16 January 2021

**Submission with regard to Development Application DA2021/2435  
Alteration and additions to residential development – Alterations and additions to a  
dwelling house including a spa  
40 Hillcrest Avenue, Mona Vale, NSW**

**Figure 3 – Development within the foreshore building line area**

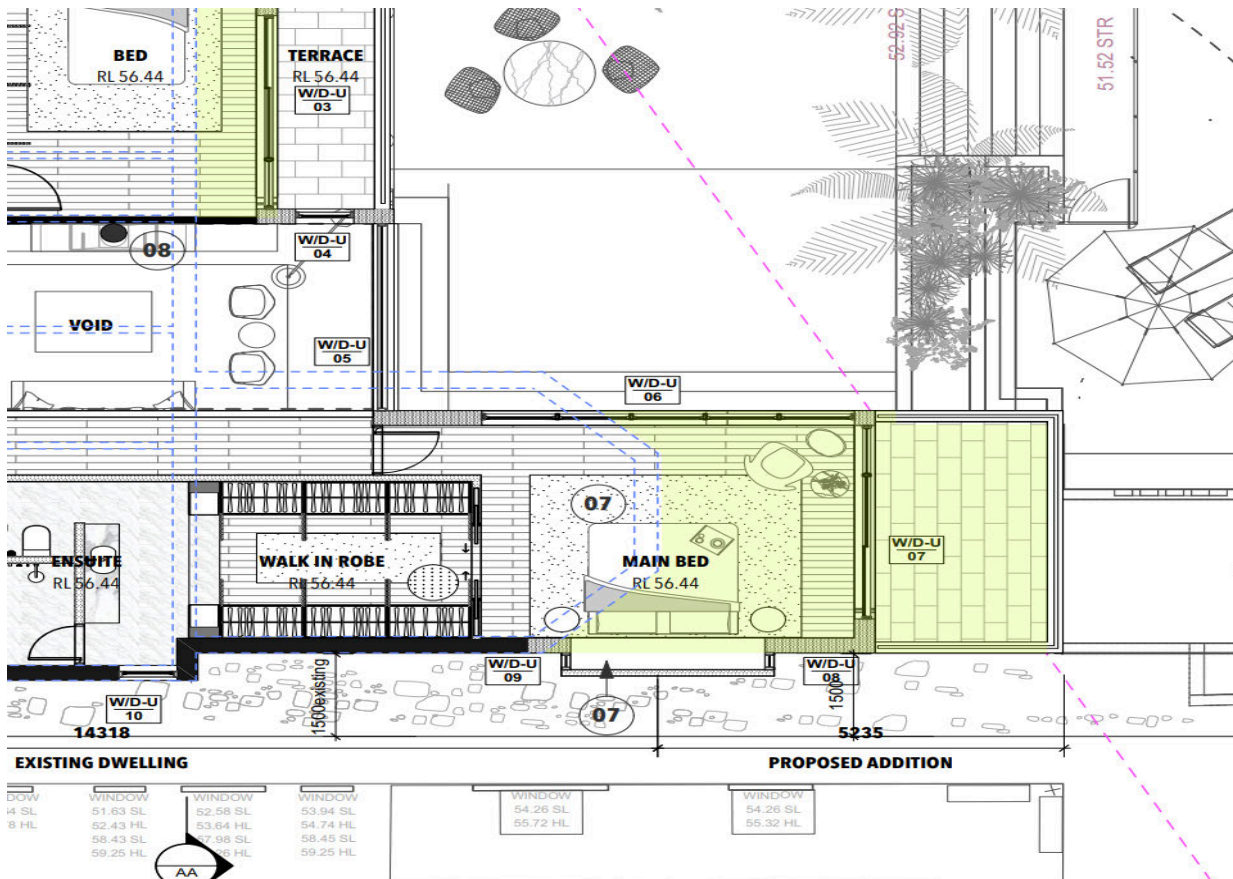
The proposed new balcony, spa and cabana are all contained within the foreshore area. The purple hatched line shown in the extract from submitted DA plans in figure 3 shows the location of the foreshore building line and encroachment of the proposed balcony within the foreshore area.

Council's Natural Environment – Coastal referral responses concludes that the DA includes proposed works like pool, cabana and improvement in recreation area consistent with Cl. 7.8(2)(b). This submission agrees that the pool improvements / spa and cabana alterations do not conflict with Cl. 7.8(2)(b) but contends that the proposed balcony addition amounts to extending the footprint of the building further into the foreshore area contrary to Cl. 7.8(2)(a).

In accordance with Clause 7.8 of the LEP, the proposed balcony should be removed from the submitted plans. It should also be noted that this submission includes further concerns arising from the proposed balcony.

**Figure 4 – Eastern elevation of proposed development**

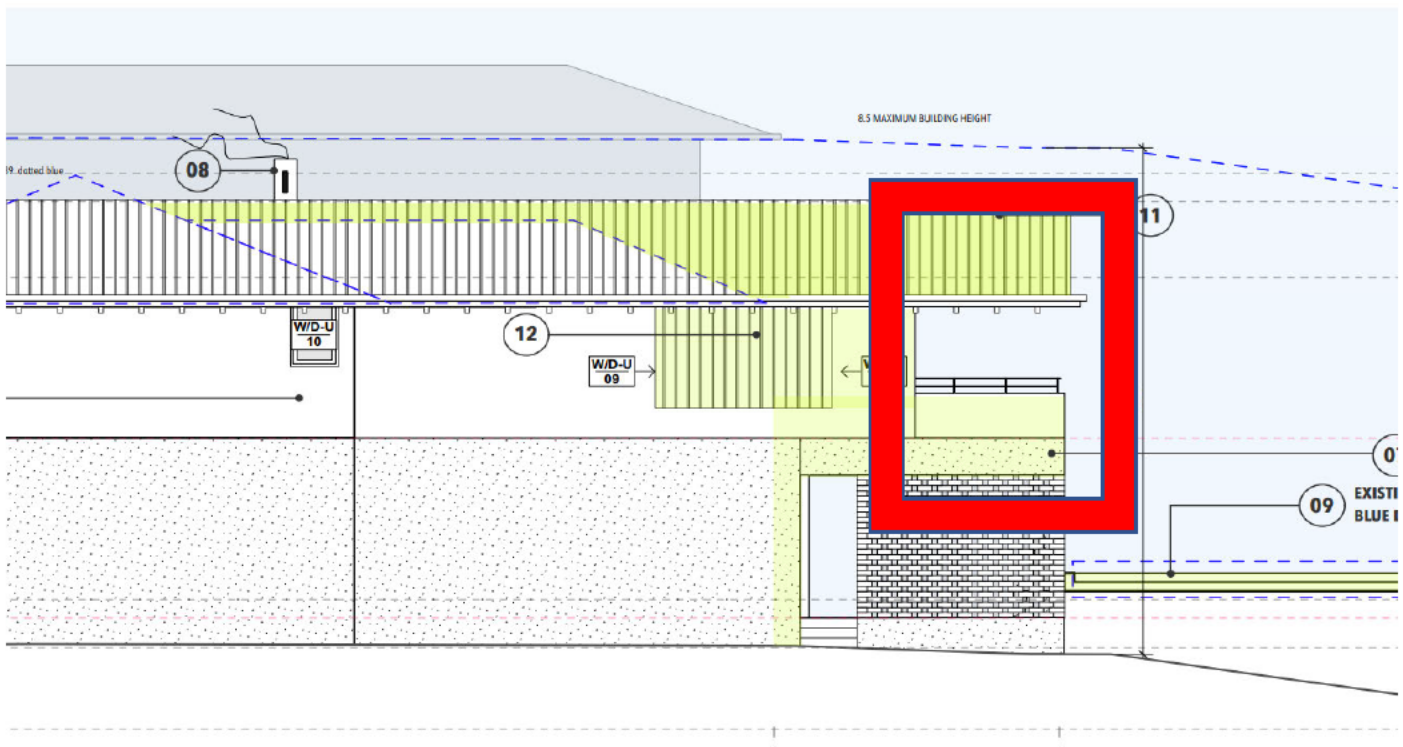
The proposed rear balcony serving the master bedroom on the eastern elevation is located to look directly towards my client's private open space area to the rear which includes the outdoor dining area and pool area. The proposed new balcony is also directly adjacent to the existing balcony to the rear of no. 42 Hillcrest Avenue.

The proposed development is of a height and side setback which would facilitate direct overlooking at a close proximity and the location of the proposed balcony would exacerbate this impact.

It is the physical built form and proposed siting of the eastern elevation addition which should be amended to reduce the impact of the proposed development, or the subject DA should be refused given that it is contrary to DCP Control C1.5, as well as the other stated controls.

Figure 4 details the area of impact. It is requested that the proposed balcony be removed or pulled back to reduce the level of impact to arise from the proposal and include a hipped rather than gable end to limit solar impacts.

**Comment:** The proposed development includes living areas and private open space areas (proposed balcony) in close proximity to my client's bedroom. The noise arising from the proposed siting of the new dwelling and particularly the open balcony, would result in unacceptable levels of noise and have an impact on my client's acoustic privacy contrary to DCP Control C1.6. Should the requested amendment to remove or pull back the balcony, as shown in figure 4, be incorporated the acoustic impacts would be reduced.

**Figure 5 - Recommendation to amend the siting of the proposed development by pulling back from the rear boundary**

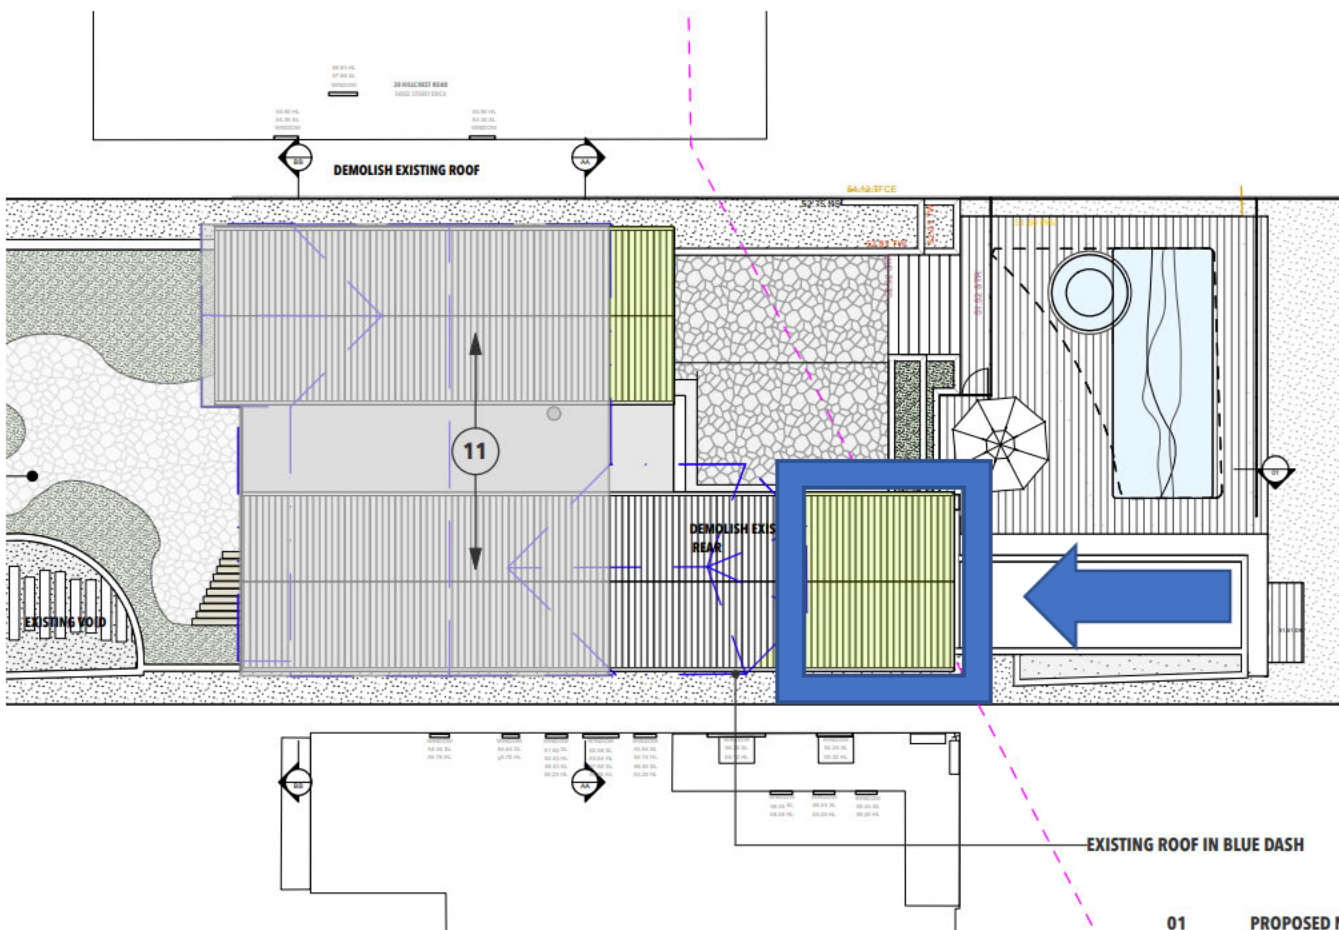
However, the rear set back where the balcony extends along the eastern elevation presents a significant impact. Although numerically compliant with the rear setback, the foreshore building line applies. The close proximity and overbearing height, bulk and scale of the proposed development results in a development that does not achieve the desired future character of the locality, where the bulk and scale is not minimised and there is an unreasonable impact on privacy and solar access contrary to the outcomes of this control.

To address this impact, it is recommended that the proposed development is pulled back to off the side and rear boundary. As shown in figure 4 and figure 5, it is requested that amended plans be submitted to remove the proposed balcony to achieve an improved outcome and address the non-compliance of the stated controls.

- Pull back the side and rear eastern elevation to remove the balcony and increase the side setback of the eastern boundary to 2.5 metres. From an assessment of the submitted plans, there is scope within the building design to be varied to accommodate these amendments by reducing the size of the internal pavilion and achieve an improved outcome which address the compliance of the stated controls to reduce the overbearing and privacy impacts and address non-compliance with the stated DCP Controls.

**Figure 6 – Established rear boundary set back**

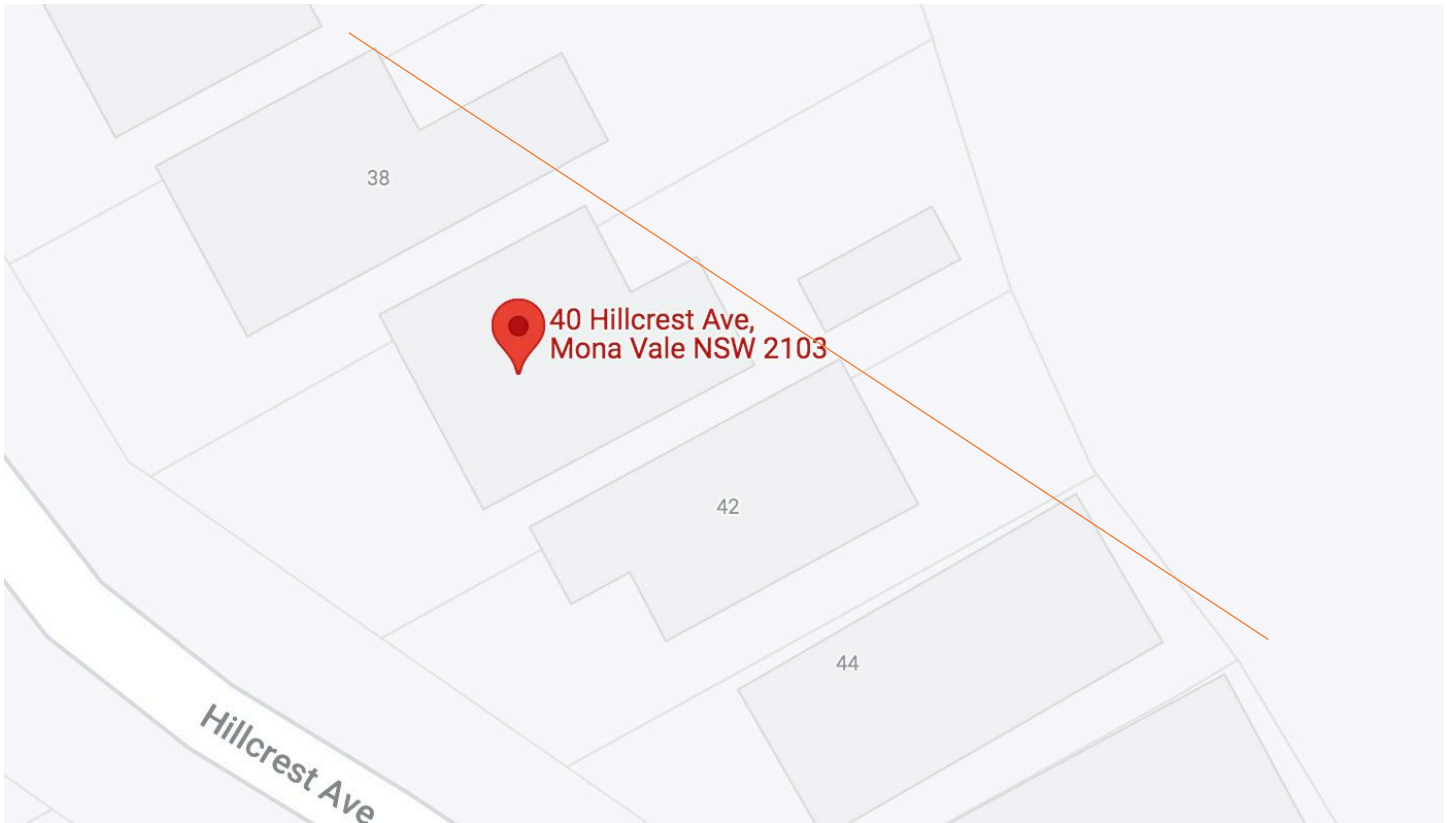
The removal of the proposed balcony would also comply with the established rear building line as shown in figure 6.
